WALLACE HOUSE
FITZROY PARK
LONDON
N6 6HT

SECOND FLOOR PLAN

120

PLANNING

01 PROPOSED SECOND FLOOR PLAN

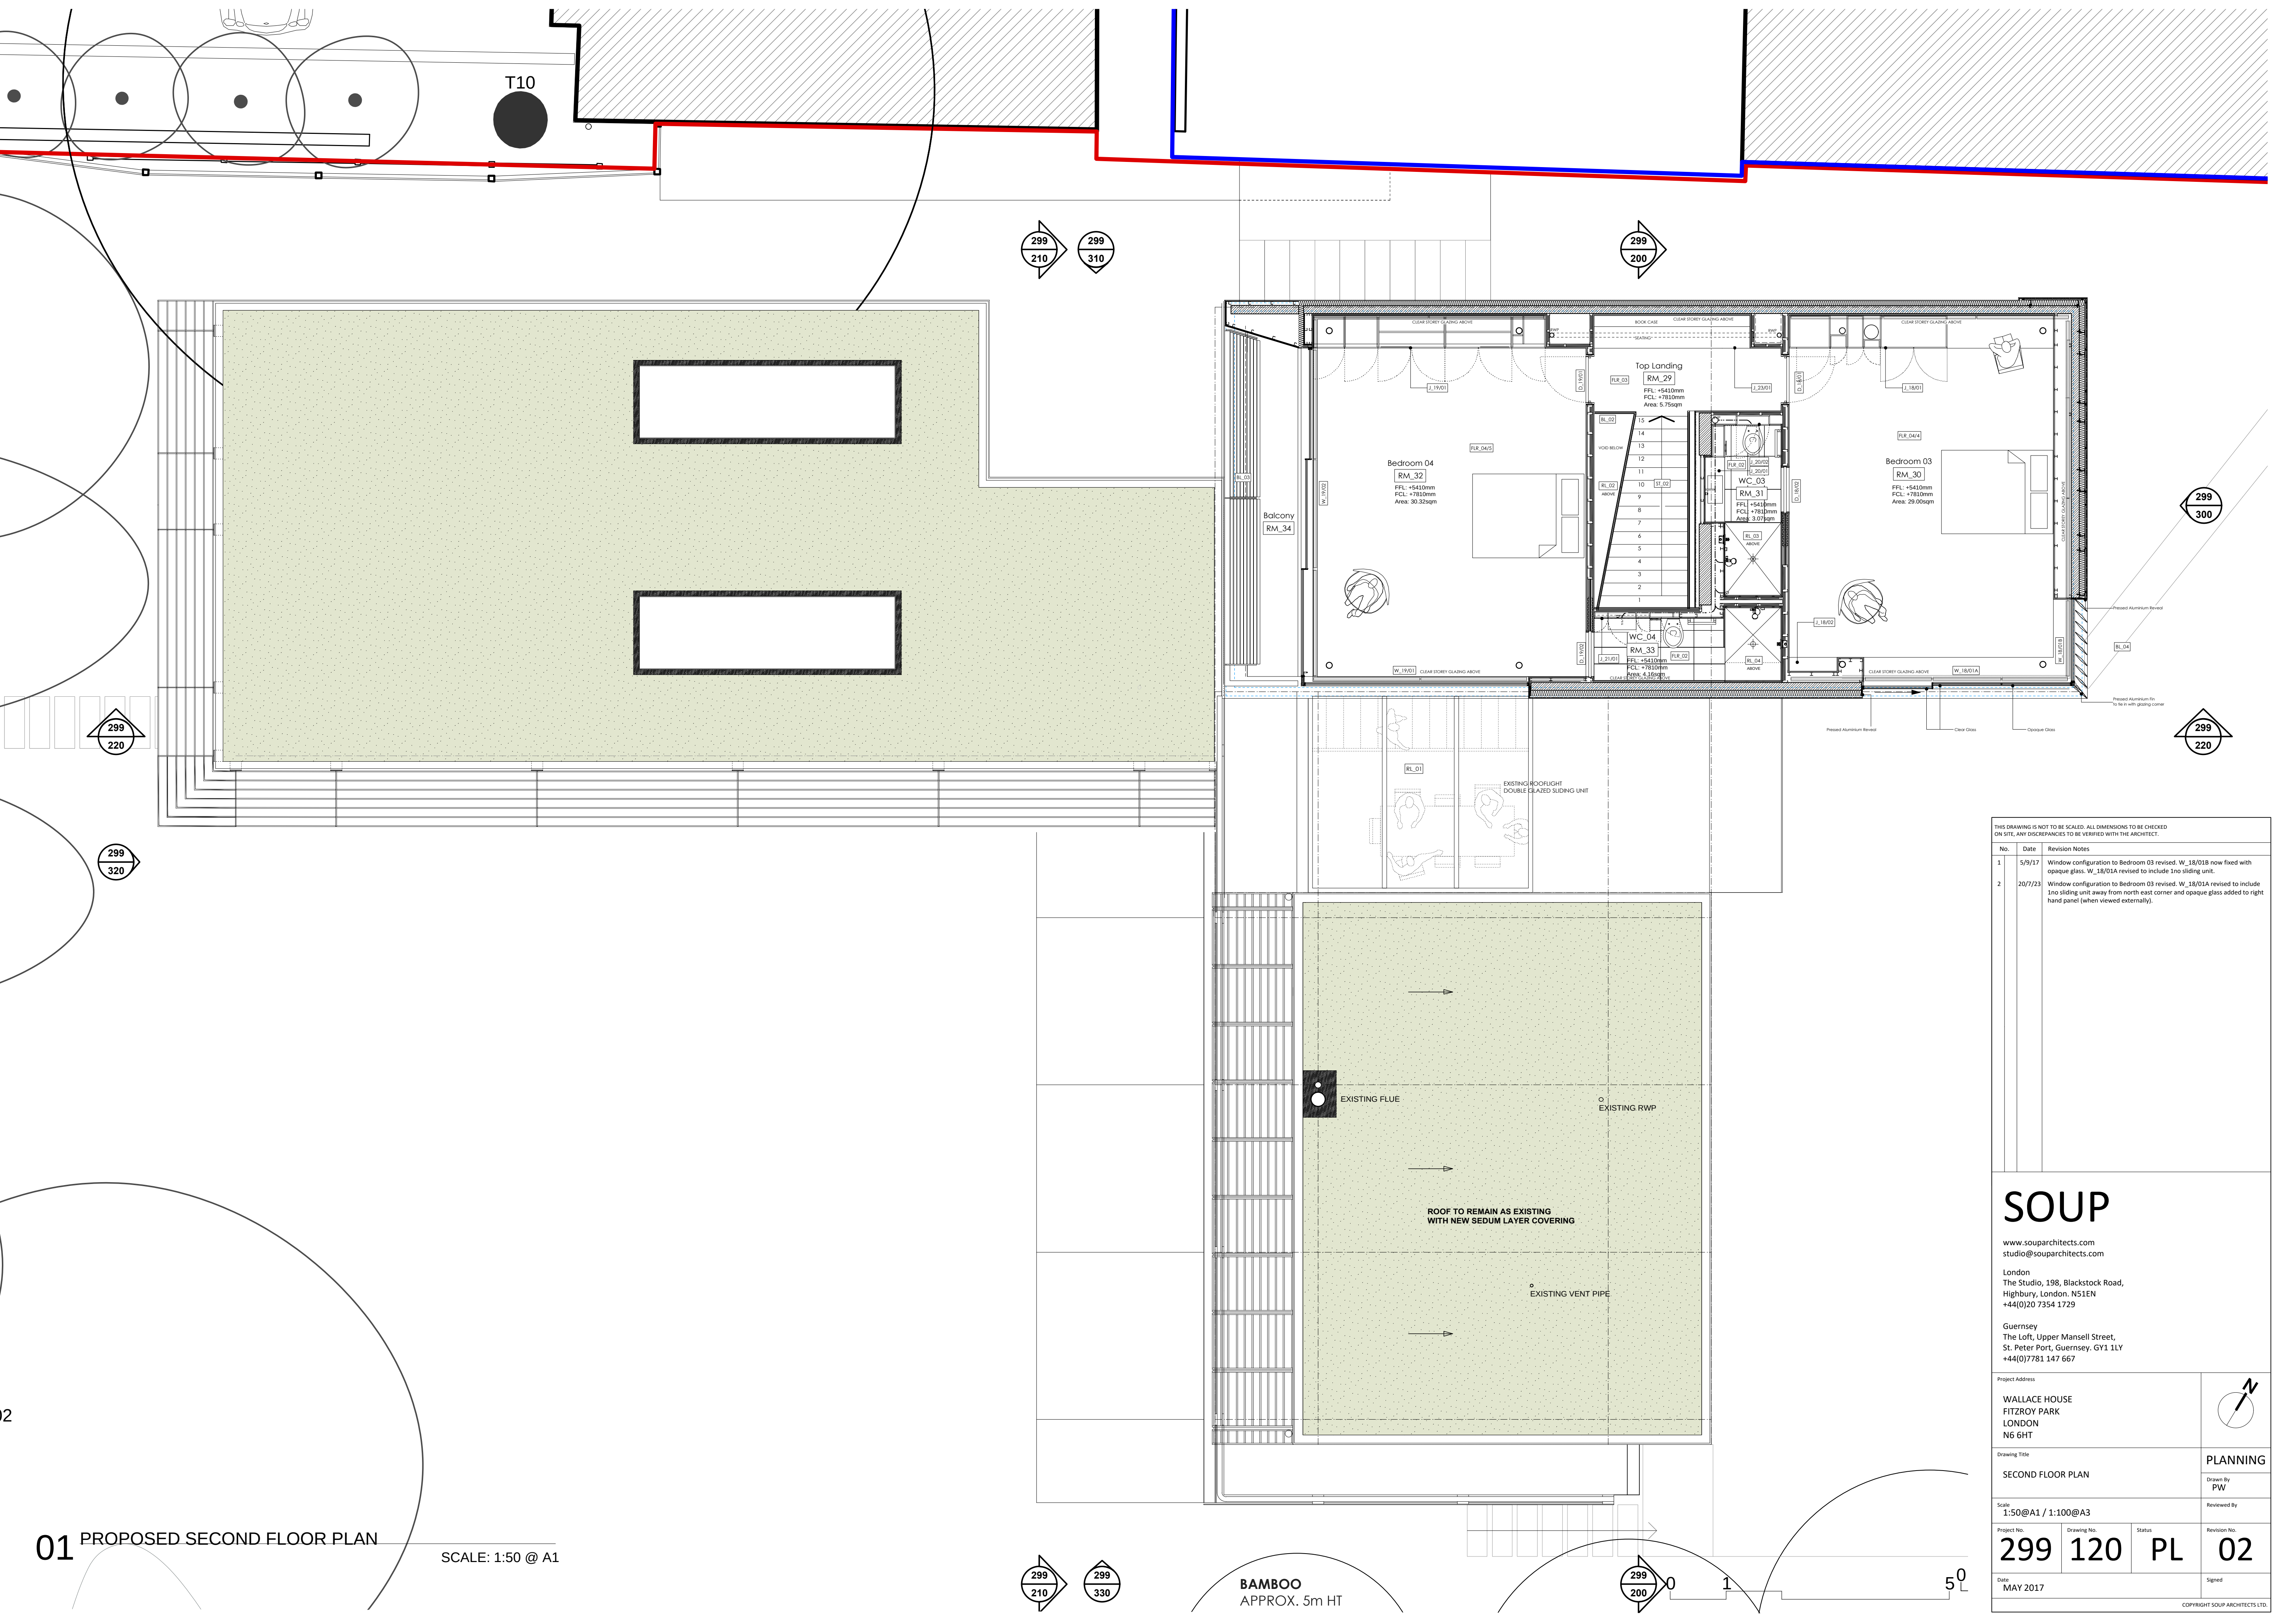
No.	Date	Revision Notes
1	5/9/17	Window configuration to Bedroom 03 revised. W_18/01B now fixed with opaque glass. W_18/01A revised to include 1no sliding unit.
2	20/7/23	Window configuration to Bedroom 03 revised. W_18/01A revised to include 1no sliding unit away from north east corner and opaque glass added to right hand panel (when viewed externally).
